Addendum #1

Re: GPPSS Classroom AV & Cabling RFP

Photos of existing floor to ceiling mounts:

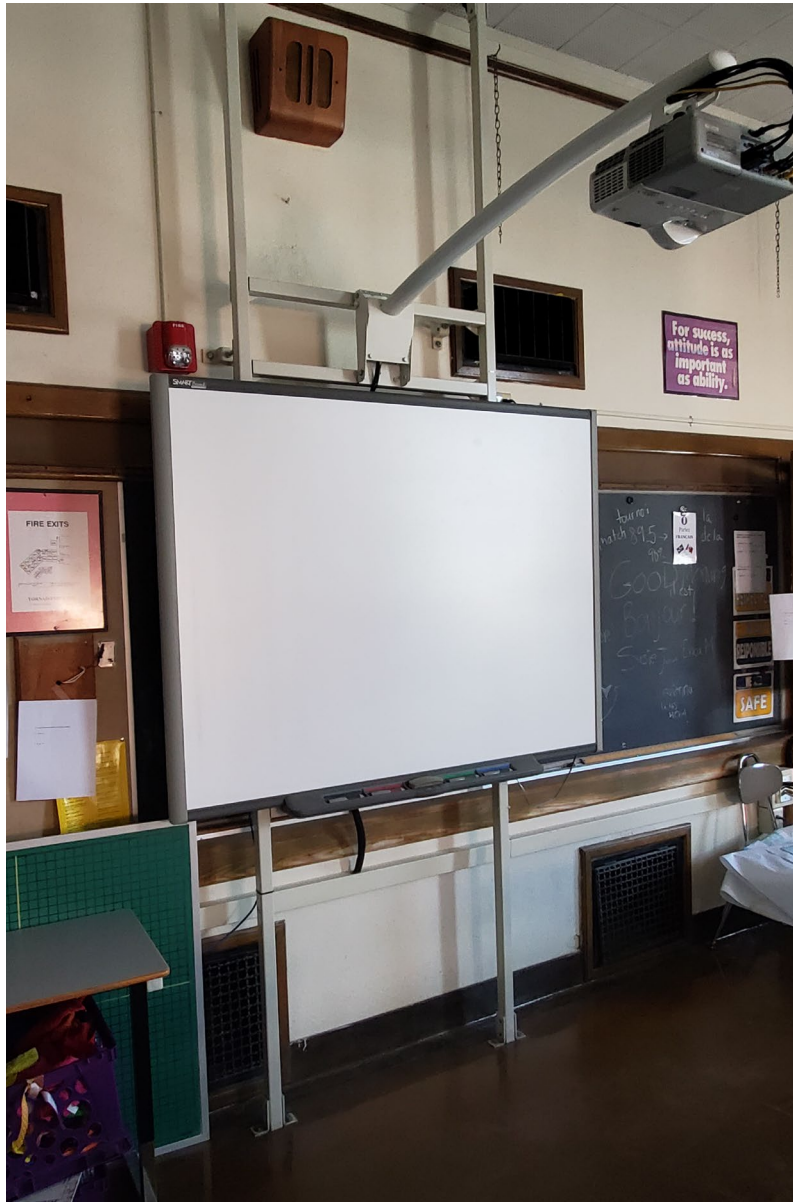
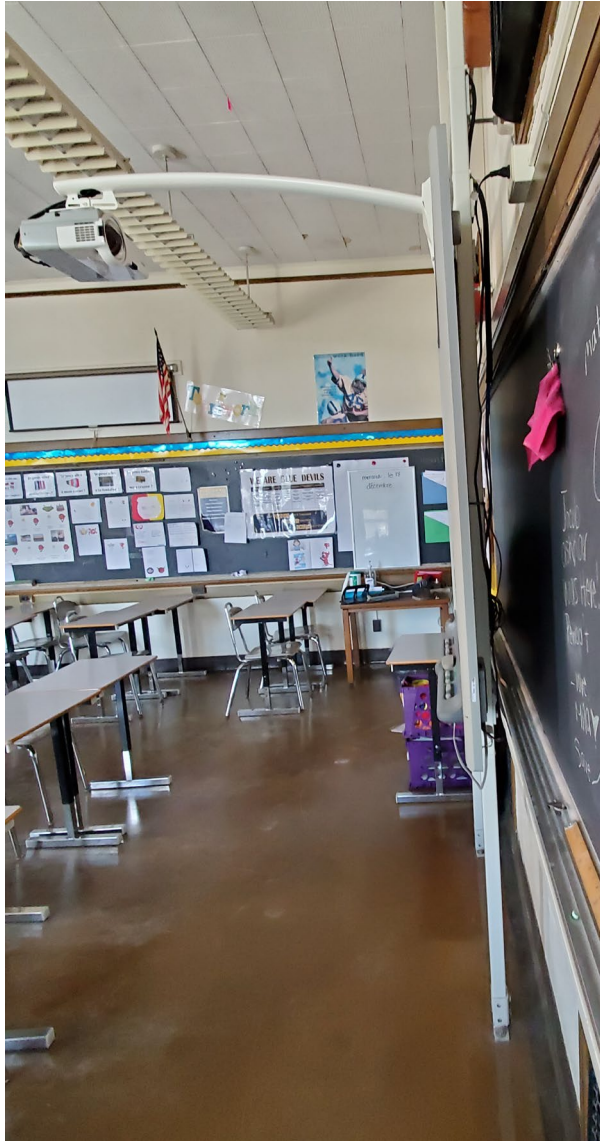
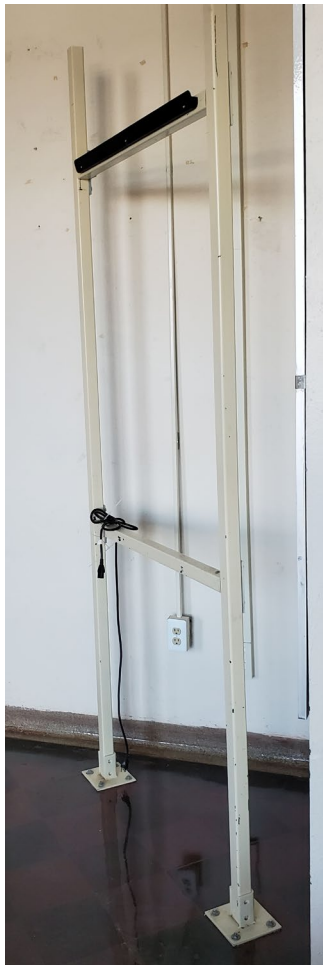
QUESTION	ANSWER
1. Can we just bid on a single section of the RFP?	Yes – you can, however we also encourage you to partner with others for a complete solution.
2. Can you provide a photo of a room that currently has a floor to ceiling mount for AV?	See photos at the end of this addendum.
3. Are there loading docks at each building?	The following building has a loading dock: Parcels MS
